SERVICE TIPS

82-16

GAME: POWER SUPPLY #08-00007-001 USED ON "QIX", ALPINE SKI, WILD WESTERN,
KRAM, ELECTRIC YO YO.

SUBJECT: BR1 AND BR2 HEATING UP TO THE EXTENT OF BREAKING DOWN INTERNALLY.

FIGURE 2

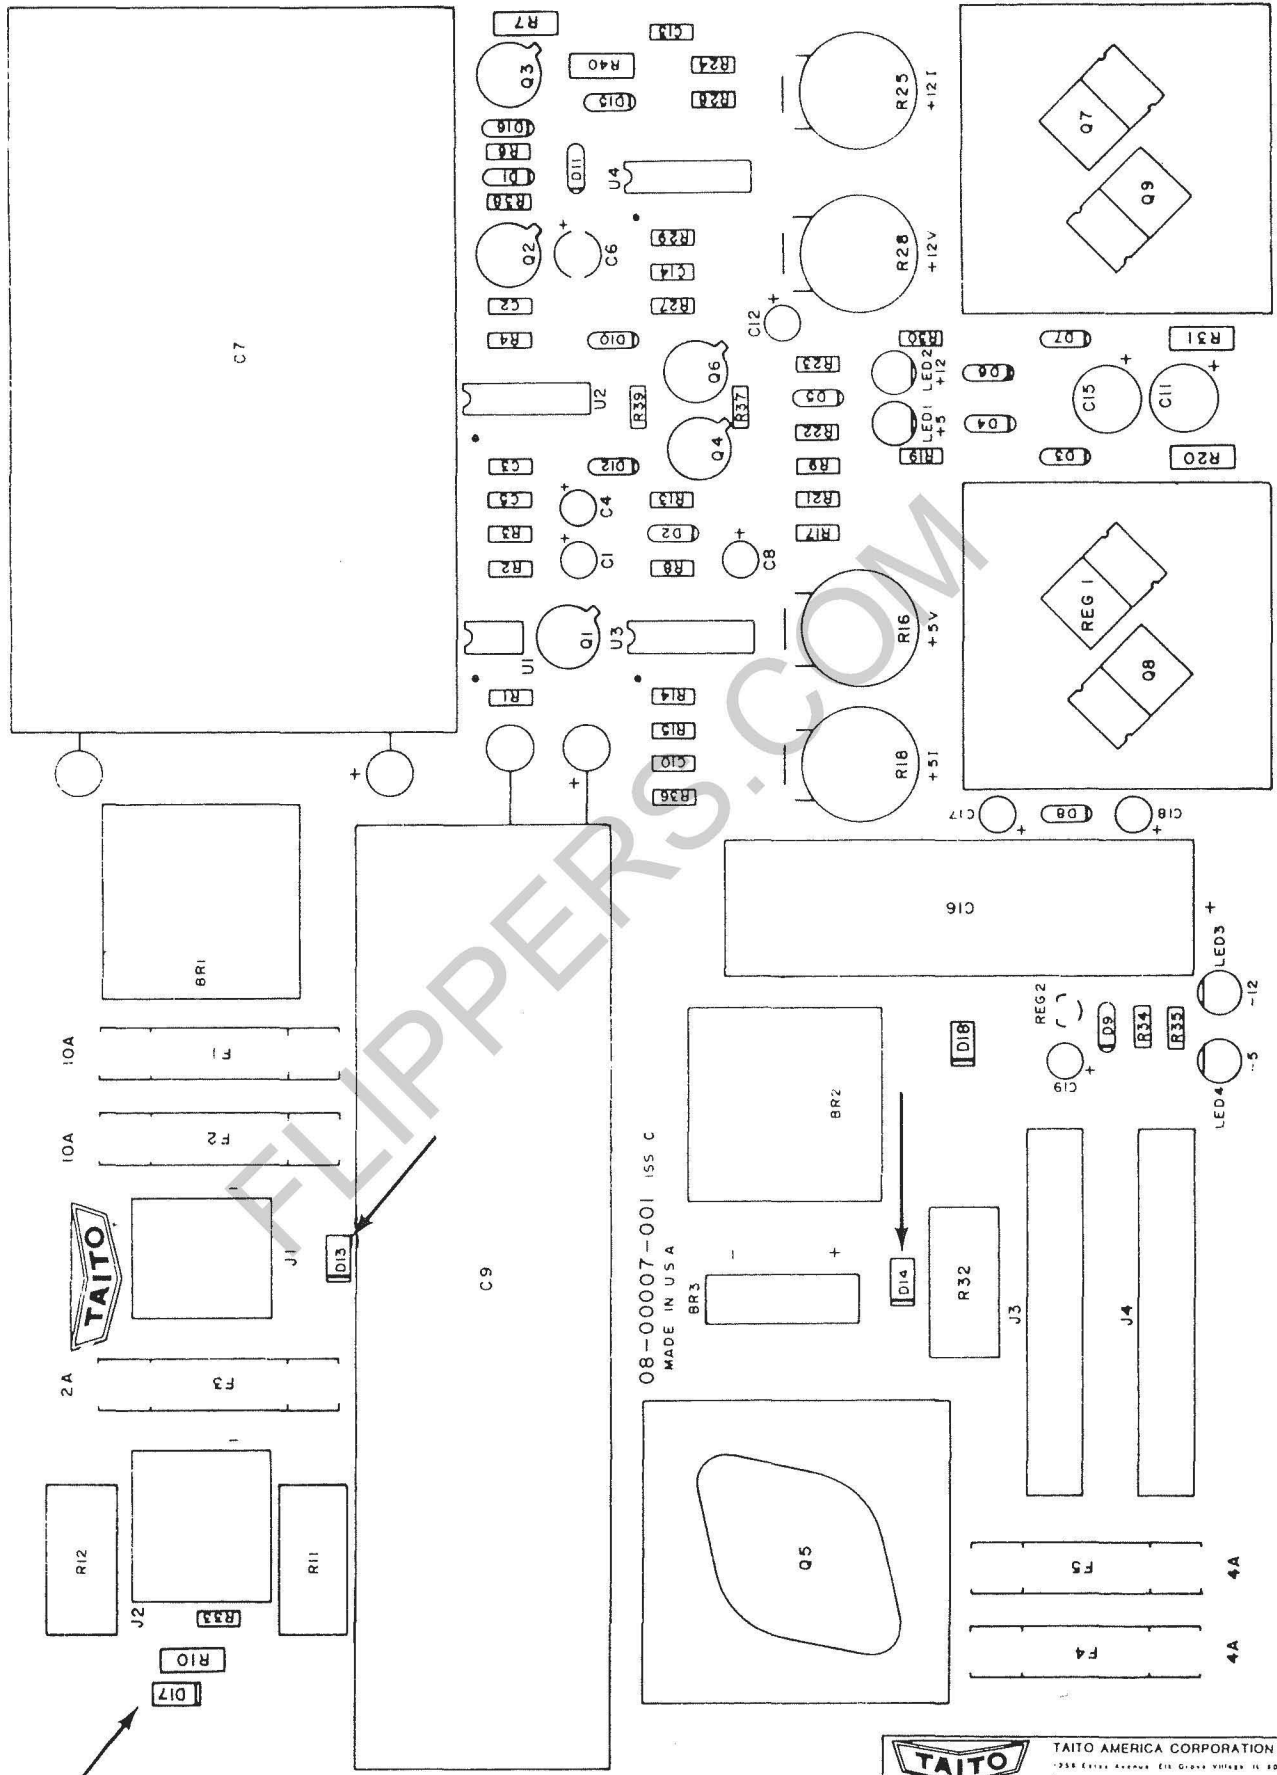
THERE ARE COMPONENTS UNDER THE POWER SUPPLY THAT LOOK LIKE DIODES (REFER TO FIGURE 1 AND 2)(ON ISS. "C" OF THE POWER SUPPLY THEY ARE CALLED D13, D14, D17 AND ARE ON THE COMPONENT SIDE). THESE COMPONENTS ARE CALLED TRANSORBS. THEY ARE USED TO COMPENSATE FOR FLUCTUATING A.C. LINE VOLTAGES. MEASURING THEM OUT OF CIRCUIT, OTHER THAN CHECKING FOR SHORTS, IS USELESS. THE ONLY WAY TO TEST THEM IS TO TAKE THEM OUT OF CIRCUIT, AND THEN POWER UP THE POWER SUPPLY WITH A LOAD. IF THE VOLTAGE, AFTER ADJUSTMENT, IS CORRECT, THEN THE TRANSORB NEEDS TO BE REPLACED.

ENSURE THAT THE SCREWS ON C7 AND C9 (REFER TO FIGURE 2) ARE TIGHT. AFTER THE SCREWS ARE TIGHT, MEASURE, WITH THE METER IN AC VOLTAGE MODE, THE OUTPUT OF +5V. THE RIPPLE SHOULD BE LESS THAN A QUARTER OF A VOLT (0.25 V). IF NOT, C7 COULD BE THE PROBLEM.
